802.3dj D1.3 Comment Resolution Logic Track

Gary Nicholl (Cisco), Logic Track Lead Editor
Eugene Opsasnick (Broadcom), Logic Editor
Matt Brown (Alphawave Semi), 802.3dj Chief Editor

SM-PMA / InnerFEC Skew Comments <452, 26, 27>

Figure 169-5—800GBASE-R Skew points for a PHY with two 800GAUI-n

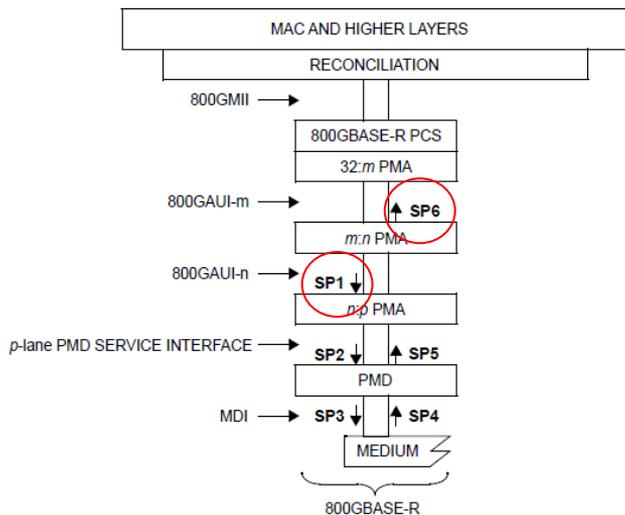
As pointed in in comment #26 and #27, the skew at each physical instantiated interface is defined in 116, 169, and 174 and also the numbers. The PMA skew constraints may be derived from these.

There is no intent to change the skew reference points and or skew numbers from what is currently in the draft.

However the description of the various skew reference points may need to be updated to reflect the more complicated stackups that are permitted in 802.3dj (e.g. co-located BM-PMA + SM-PMA + InnerFEC, etc)

Note: SP1 and SP6 are the only skew points directly related to the PMA. SP2,3,4 and 5 are all related to the PMD.

Observation: The skew definitions in 116/169 (as above) are not self-consistent with the definitions in 120/173.

Figure 169-5—800GBASE-R Skew points for a PHY with two 800GAUI-n

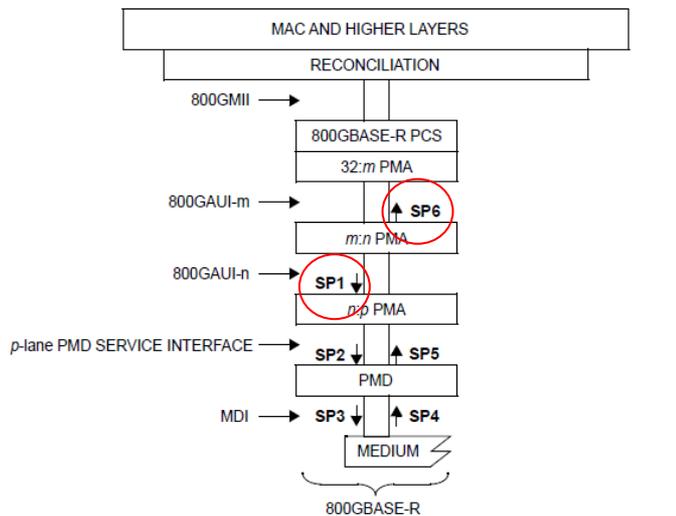
Current skew and skew variation numbers are specified as follows:

Figure 169-5—800GBASE-R Skew points for a PHY with two 800GAUI-n

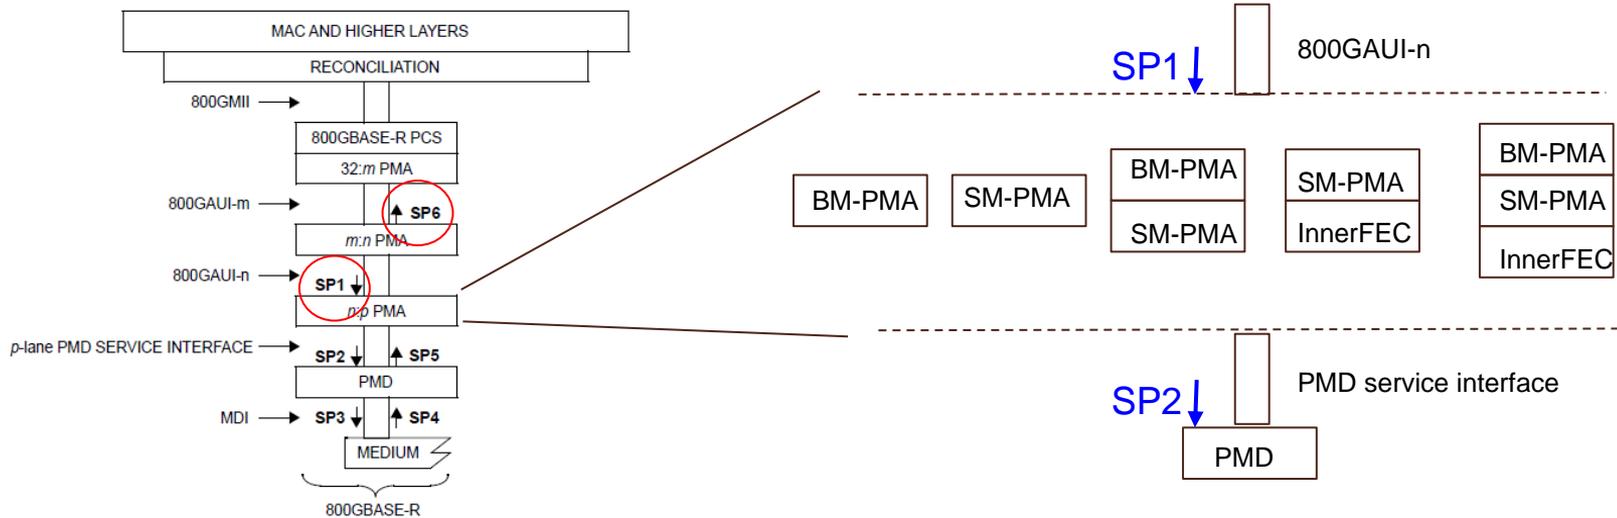
The challenge is that in 3dj there is no longer just a single PMA sublayer between SP1 and SP2. There can be a combination of a number of different (but always co-located) sublayers as shown below:

However in all these cases the location of SP1 and SP2 are not be changed, and neither are the values.

SP1 is at the output of the AUI-n closest to the PMD and SP2 is at the PMD input

Change the definition of SP1 and SP6 in 169.5 as follows::

- ~~SP1 on the 800GAUI-n interface, at the input of the PMA closest to the PMD~~ | SP1 on the output of the 800GAUI-n interface closest to the PMD
- SP2 on the PMD service interface, at the input of the PMD
- SP3 at the output of the PMD, at the MDI

- SP4 at the MDI, at the input of the PMD
- SP5 on the PMD service interface, at the output of the PMD
- ~~SP6 on the 800GAUI-n interface, at the output of the PMA closest to the PCS or DTE 800GX~~
SP6 on the input of the 800GAUI-n interface closest to the PCS or DTE 800GXS

Make similar changes in 116.5 and 174.5

Figure 176D-3—Inter-sublayer service interfaces for a 200GAUI-1, 400GAUI-2, 800GAUI-4, or 1.6TAUI-8 C2M

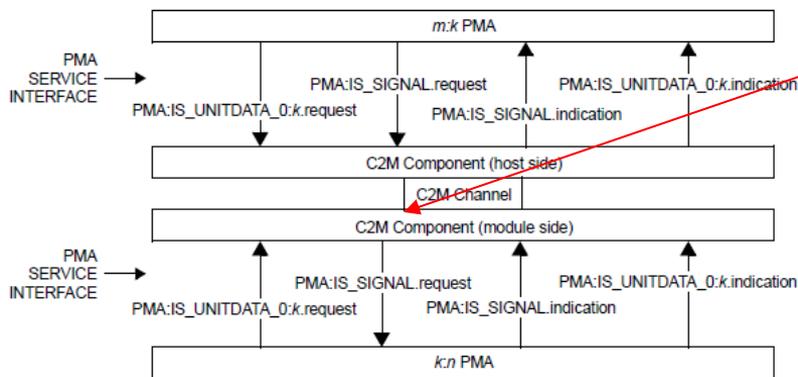
More thoughts. Does the introduction of the XAUI Channel and XAUI Component change any of this. Maybe the skew points at SP1 and Sp6 should now be defined as part of the AUI Component and not the SM_PMA ?

Since SP1 is defined at the output of the AUI-n closest to the PMD, isn't it now defined at the input of the C2M Component and not the input of the PMA (as it used to be) .

Maybe the updated definition of SP1 I came up with earlier:
 "SP1 on the output of the 800GAUI-n interface closest to the PMD"
 Should be further refined to:
 "SP1 on the 800GAUI-n interface , at the input of the AUI Component closest to the PMD "
